SUMMERLIN

PRELIMINARY OVERALL AREA DEVELOPMENT PLAN

POADP # 427 - D

Re: Revisions to the Approved Preliminary Overall Area Development Plan (POADP) for Summerlin, POADP #427-C

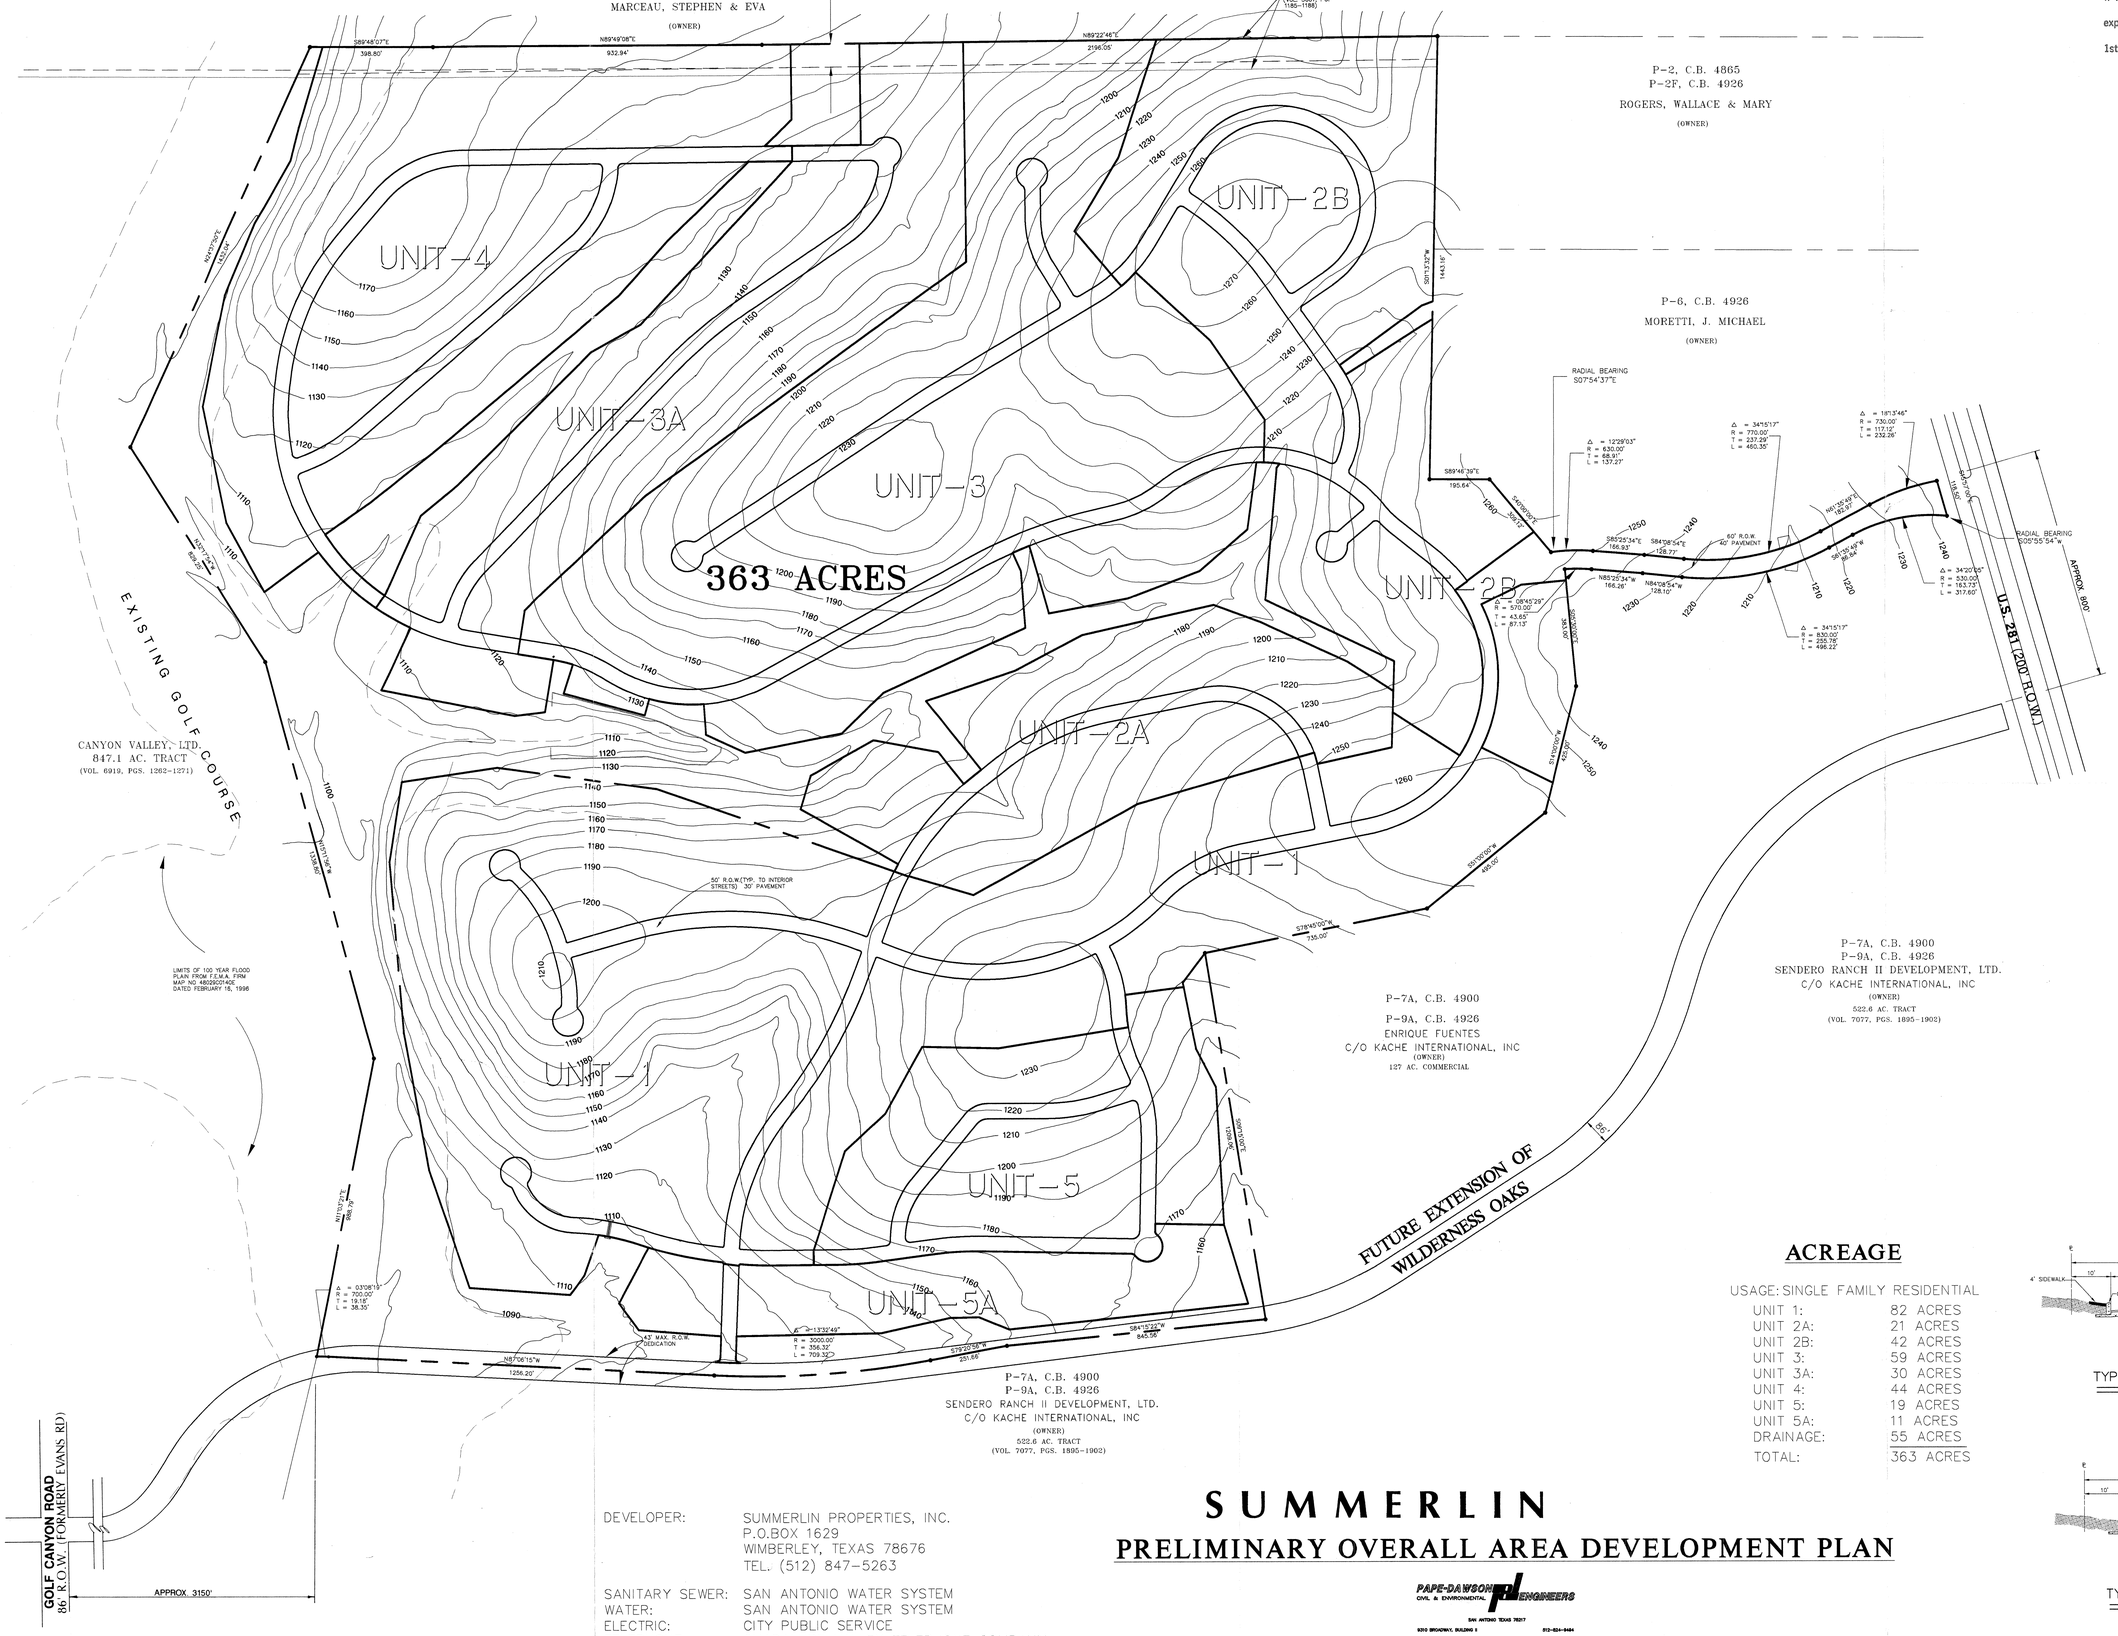
The City Staff Development Review Committee has reviewed Summerlin +362 Acre Tract Subdivision Preliminary Overall Area Development Plan # 427 - D. Please find enclosed a signed copy for your files. Although your plan was accepted, please note the following:

- Based on the topography, a Flood Plain Study and drainage review will probably be required during the platting process.
- In consideration of public safety and convenience, excessive grades by reason of topography should be avoided in street layouts and arrangements.

- This development will probably need to conform to requirements associated with development over the Edwards Aquifer. For additional information about these requirements you can contact SAWS at 704-7305.

- Access and R.O.W. issues along State facilities will need to be resolved with the Texas Department of Transportation (TXDOT). For information about these requirements you can contact TXDOT at 615-5814.

- If Wilderness Oaks is developed as a pilot project, it will probably require a 110' of ROW.
- This development will need to comply with tree preservation ordinance #85262. For information about these requirements you can contact Building Inspections at 207-7102.

- It will be expected that you will plat all of the property depicted in your POADP, to include: floodpains, drainage areas and open space.
